HISTORIC AND DESIGN REVIEW COMMISSION

HDRC CASE NO: 2021-172
ADDRESS: 129 W AGARITA AVE
LEGAL DESCRIPTION: NCB 1767 BLK 1 LOT E 35 FT OF 11 & W 25 FT OF 12
ZONING: R-4, H
CITY COUNCIL DIST.: 1
DISTRICT: Monte Vista Historic District
APPLICANT: CHRISTOPHER VERETTE/CrabApple Designs LLC
OWNER: Thomas Seerden/SEERDEN THOMAS R & GAYLE W
TYPE OF WORK: Repairs, painting, window replacement
APPLICATION RECEIVED: March 30, 2021
60-DAY REVIEW: Not applicable due to City Council Emergency Orders
CASE MANAGER: Rachel Rettaliata

The applicant is requesting a Certificate of Appropriateness for approval to replace two windows on the rear elevation with an aluminum clad wood casement window with a fixed transom.

PROPOSED WINDOW CHANGE

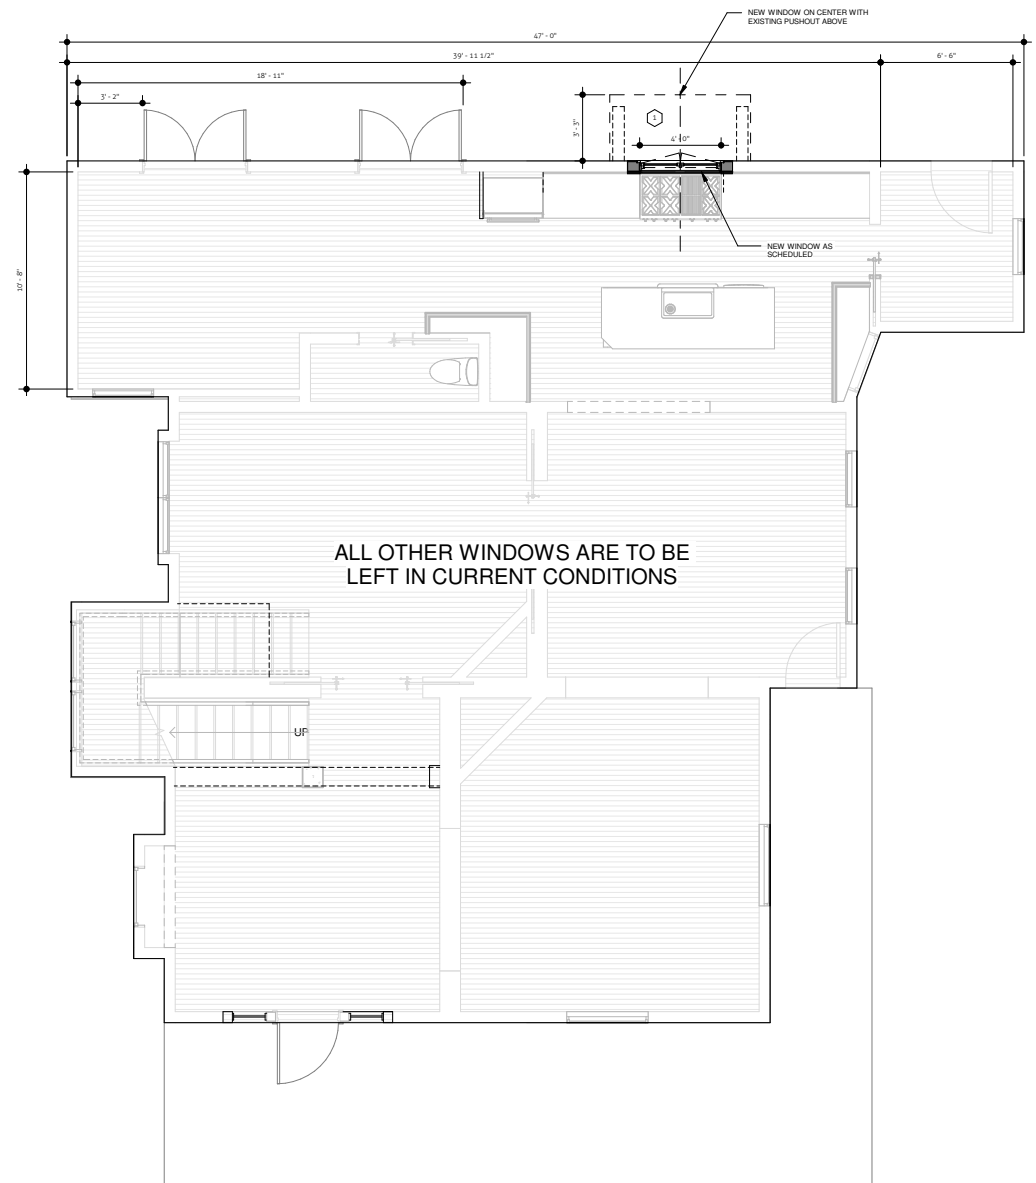
- b. WINDOW REPLACEMENT: EXISTING CONDITION – The applicant has proposed to replace two (2) one over-one wood windows located on the north (rear) elevation. The windows are fully wood and are located beneath a second story box bay window. The applicant has proposed to replace the existing windows with one Marvin aluminum-clad wood casement window with a fixed transom featuring simulated divided lites. Guideline 6.A.iii for Exterior Maintenance and Alterations states that historic windows should be preserved. At this time, the applicant has not provided evidence that the existing windows are not original to the structure. Additionally, Guideline 6.B.iv for Exterior Maintenance and Alterations states that new windows should be installed to match the historic or existing windows in terms of size, type, configuration, material, form, appearance, and detail when original windows are deteriorated beyond repair. The documentation provided does not show that the windows are deteriorated beyond repair. Staff finds the proposal inconsistent with the Guidelines and finds that the existing windows should be repaired in place.

- c. WINDOW REPLACEMENT: REPLACEMENT PRODUCT – The applicant has proposed to replace two (2) existing one-over-one wood windows with one Marvin aluminum-clad wood casement window with a fixed transom featuring simulated divided lites. According to the Standard Specifications for Original Wood Window Replacement, meeting rails must be no taller than 1.25". Stiles must be no wider than 2.25". Top and bottom sashes must be equal in size unless otherwise approved. The proposed replacement product does not match the existing windows in material, configuration, and form. Staff finds the proposal inconsistent with the Standard Specifications for Original Wood Window Replacement.

Staff does not recommend approval based on findings a through c. Staff recommends that the applicant repair the existing windows in place.

- i. That the applicant replaces the existing windows with a fully wood window product that meets staff's standard window specifications and submits updated specifications to staff for review and approval. The windows should feature an inset of two (2) inches within facades and should feature profiles that are found historically within the immediate vicinity. Meeting rails must be no taller than 1.25" and stiles no wider than 2.25". White manufacturer's color is not allowed, and color selection must be presented to staff. There should be a minimum of two inches in depth between the front face of the window trim and the front face of the top window sash. This must be accomplished by recessing the window sufficiently within the opening or with the installation of additional window trim to add thickness. Window trim must feature traditional dimensions and architecturally appropriate sill detail. Window track components must be painted to match the window trim or concealed by a wood window screen set within the opening. Faux divided lites are not permitted.
